FILE: X087762 **DATE:** 19 June 2025

SUBJECT: Information Relevant To Item 12.6 - Post Exhibition - Planning Proposal - 47-51 Riley Street, Woolloomooloo - Sydney Local Environmental Plan 2012 and Sydney Development Control Plan 2012 Amendment

Figure 7: Riley Street elevation in context of surrounding development - recommended amendments to draft planning controls following public exhibition

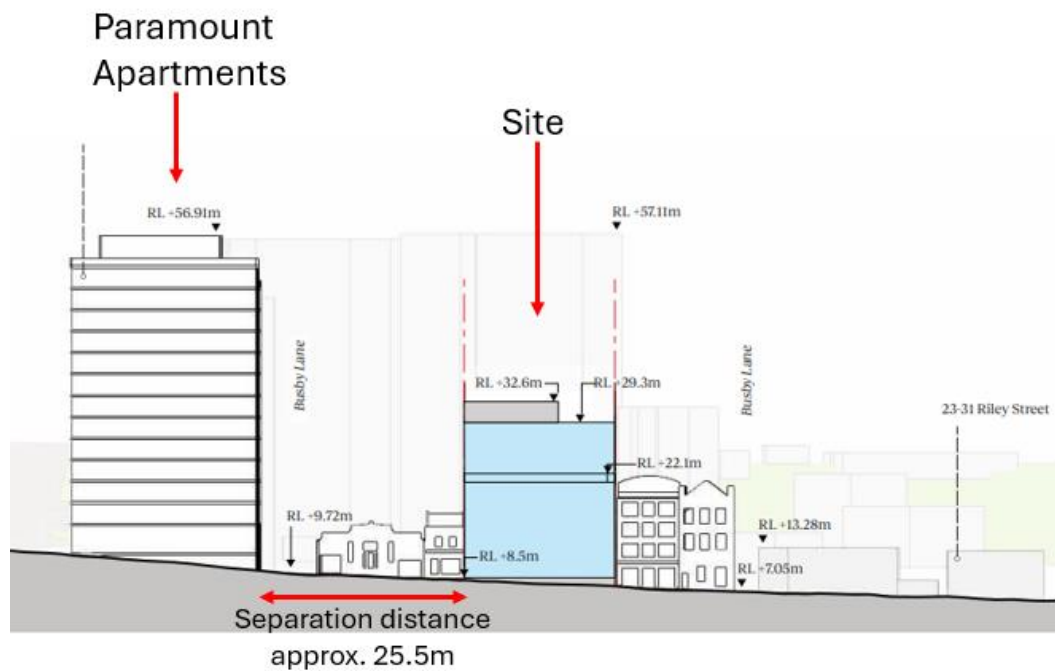
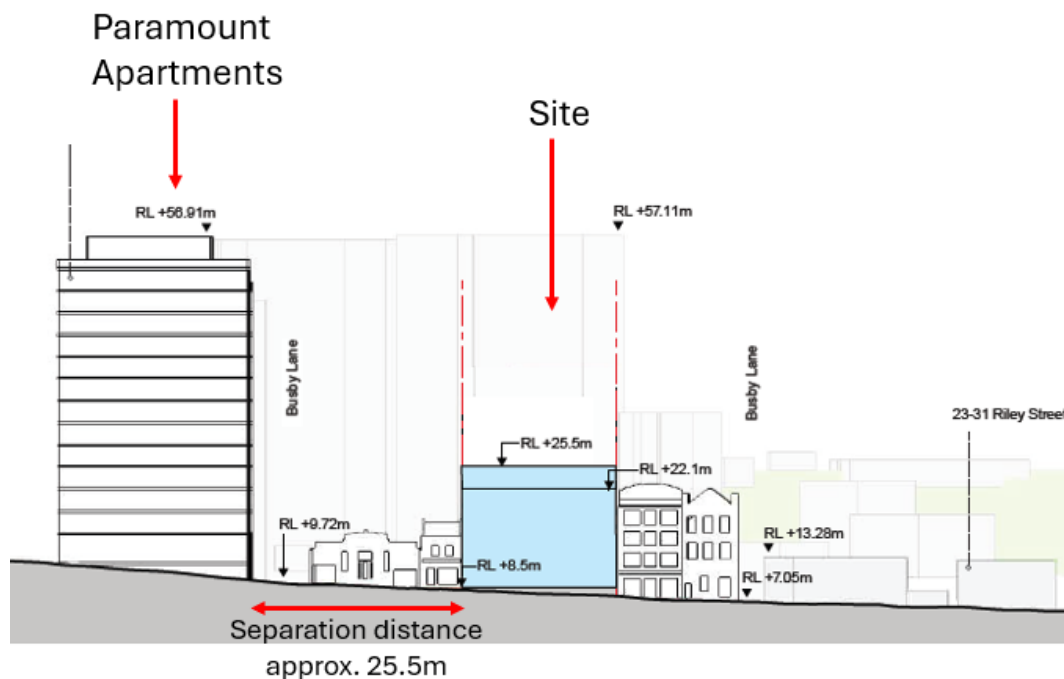
At the meeting of the Transport, Heritage and Planning Committee on 16 June 2025, reference was made to the images at Figures 6 and 7 in the subject report (reproduced below with dimensions and notes added). AHD RL is measured above sea level datum where as LEP height is typically above the footpath. The images show:

- the separation distance between the Paramount Apartments (60-70 William Street, Woolloomooloo) and the subject site is approximately 25.5 metres,
- the proposed maximum building height is recommended to be reduced by 7.1m to RL 25.5m from the exhibited maximum height of RL 32.6m which means the max height above the footpath is 17.9m compared to the current control of 12m,
- it is recommended that there be no allowance above the RL25.5m maximum height control for a roof top lift overrun, building plant, pergola structure or communal open space, and

- the recommended reduction in height will result in a smaller building envelope, and therefore the Floor Space Ratio (FSR) control is recommended to be reduced from 3.8:1 to 3.2:1 to match.
